RE: Carmichael Commons (PLNP2019-00157)

Thank you for routing Carmichael Commons resubmittal 5 (July 2020) to WALKSacramento. We appreciate the responsiveness of the applicant to comments made by the community and WALKSacramento. We made five recommendations in our February 26, 2020 letter to support more walking by residents of Carmichael Commons and the surrounding neighborhood. We were pleased to receive the applicant's responses to our first four recommendations. Our previous recommendations are included below with a summary of the applicant responses and our responses underlined. Figure 1 shows the locations of our recommendations and numbers to clarify the locations of the specific recommendations have been added.

Figure 1

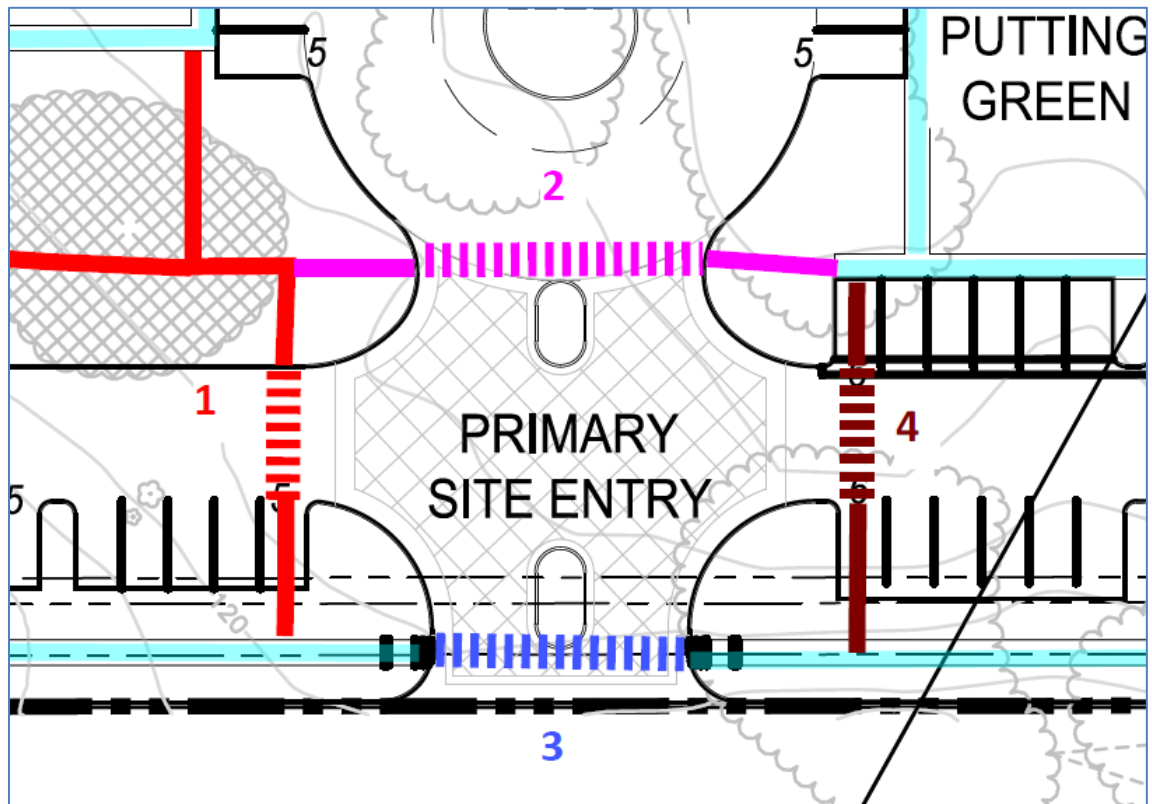
Recommendation #1: Add sidewalk segments and a crosswalk on south side of the primary site entry driveway between Hackberry Lane and the Village Square drop-off entrance. The pedestrian route has been implemented on the site plan; however, the applicant stated that the enhanced paving will indicate the driveway crossing. Enhanced paving can indicate to drivers the location of a pedestrian crossing but the paving must be different from the non-crossing areas outside of the crossing.

Recommendation #2: Add sidewalk segments and a crosswalk between the sidewalk segment in Recommendation #1 and the sidewalk parallel to the north-south drive aisle. The applicant responded that the presence of the drip line area for a Heritage Oak that to be preserved has precluded adding the sidewalk. The sidewalks that were added at the back of curb on both sides of the area of concern are a good alternative; however, the crossing isn't marked. As there will be a desire line across the eastern edge of the "Drop Off" circular drive, there should be differentiated enhanced paving and curb ramps on each side of the driveway.

Recommendation #3: Mark a crosswalk on the primary site entry driveway between the public sidewalk segment. The applicant responded that the enhanced paving is intended to act as an indicator of the crossing. The crossing paving should be differentiated from the driveway to clearly show the pedestrian area.

Recommendation #4: If feasible, also add sidewalks and crosswalk on the north side of the driveway. The site plan clearly shows a sidewalk and a crossing of the north-south driveway on the north side of the "Primary Site Entry" driveway.

Figure 2

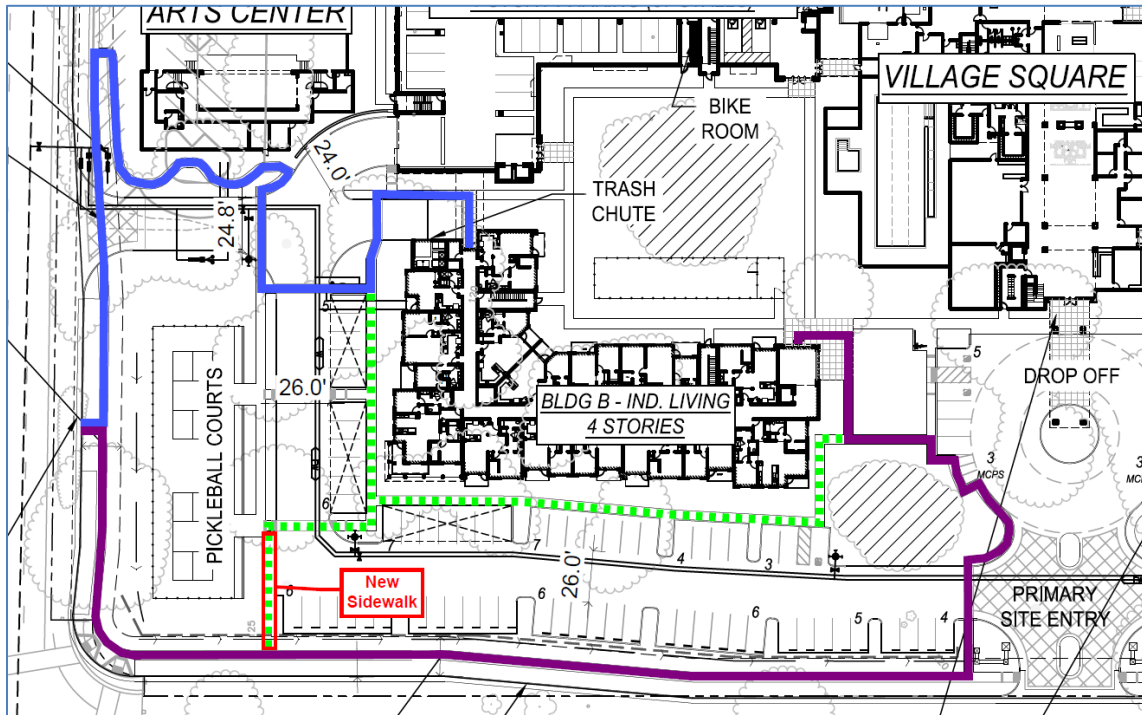
Recommendation #5: Move the access sidewalk from the west side of the emergency access driveway to the east side of the driveway and terminate near the back of the public sidewalk at the new bus stop pullout. If this is infeasible, a connection between the sidewalk on Hackberry Lane and the sidewalk around the pickleball courts should be added to provide more direct access to the bus stop. No response was provided by the applicant.

The reason we made this recommendation was to shorten and make more direct the walking path to Winding Way and the future bus stop. Considering the change to the sidewalks northeast of the pickleball courts made in the July site revision, our alternative recommendation would have a greater benefit than the primary recommendation. The figure below illustrates the walking route from Building B to the future bus stop location. The blue line indicates the route from the west entrance of Building B and the maroon line indicates the route from the north entrance. We recommend adding a sidewalk between the pickleball courts and the sidewalk on Hackberry Lane as indicated by the dashed green line in Figure 2.
